November 2, 2021

RE: Responses to Stantec's Comments
Relative to Traffic Study for
Rice Road Residential Development Project

Exhibit 3-11
Sight Triangle Case B
Departure Sight Triangles

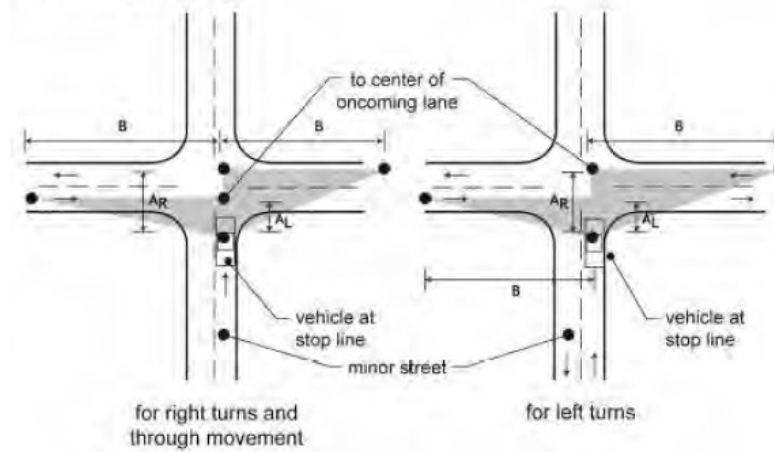
This section begins with a first paragraph appearing to describe the Intersection Sight Distance (ISD) for the proposed development driveway. From the second paragraph on, the section describes calculating the Stopping Sight Distance (SSD). Stantec recommends the study provide clarification of the sight distance measurements performed and present the information in a table or figure of the results for ease of confirmation. The figures presenting Google Earth profiles do not appear to clearly cross-reference data or results within this section of the study.

It should be noted that the intersection of Rice Road and Thomas Hill Road is an existing intersection, thus making intersection sight distance analysis would be pointless. Also, the Google Earth approximate profile was intended for visualization purposes only. Having said that, as stated in the traffic study, it was determined ample stopping sight distances are available

for the subject intersection. As for Intersection Sight Distances, the desired Intersection Sight Distances for the Massachusetts statutory prima facie speed limit of 30 miles per hour are given in the Exhibit 3-11 of massDOT Design Guide (see attached Sight Triangle) as 335' for left turns and 290' for right turns. As stated in the traffic study, the available sight distances are 500'+ to the right (west) and 350' to the left (east), thus exceeding the desired Intersection Sight Distances. The following table shows the relationship between the available sight distances, required stopping sight distances, and the desired intersection sight distances.

Land Use Group: 230 Residential Condominium/Townhouse

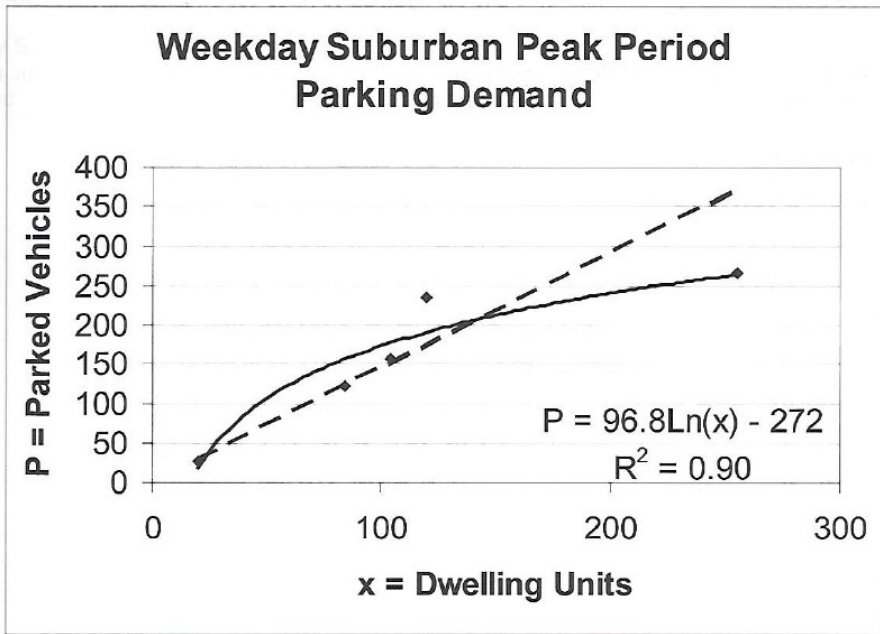
The study identifies Land Use 230 – Residential Condominiums / Townhouses were used to reference parking demand for the development’s dwellings. This land use differs from the Trip Generation analysis (LUC 220 – Multifamily Housing (Low-Rise) and LUC 230 – Residential Condominiums / Townhouses is not a code in the most current edition of the Parking Generation Manual (5th Edition). Stantec recommends AK Associates clarify why this land use code was used and from which edition of the ITE’s Parking Generation Manual. Also, AK Associates should further clarify where the peak parking demand rate in suburban areas originates from and why it is 1.68 parking spaces per unit. The Parking Generation analysis was not included in the Appendix for confirmation.

As mentioned by the review engineer, there is no land use code 230 in the 5th edition of the Parking Generation Manual. However, the 3rd edition of ITE’s Parking Generation Manual has data for the correct land use code 230 that represents the proposed residential development which

was used in the traffic study. A copy of the Parking Generation Manual's land use code 230 is attached hereto. As mentioned in the traffic study, the 85th percentile parking demand was based on condominiums/Townhouses in suburban areas. Also, it should be noted that the demand for off-street parking is greatest for residences located in suburban areas primarily due to the lack of public transportation and long distances from daily conveniences.
